Request of Class II Permissive Change

Company name: Shenzhen Junlan Electronic Ltd
FCC ID: OKUJC3511
FCC Part 15 Certification

This is to request a Class II Permissive Change for FCC ID: **OKUJC3511** originally granted on 09/02/2022

1.

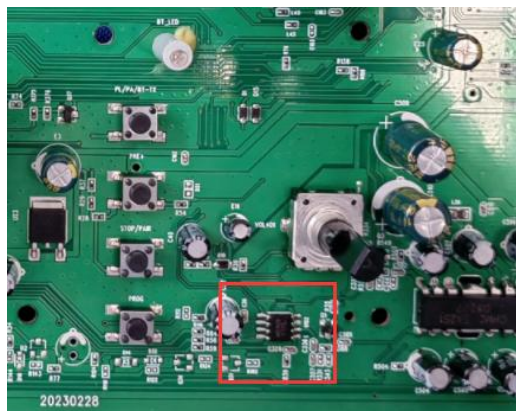
1. Add an IC (M62429FP) on the PCB board.
2. Change X1 (12MHz) to "12MHz/9PF/3225".
3. Add electrolytic capacitor (C37: CD110-16V-100UF-M) on the PCB board.
4. Add Model: JC-3511C.
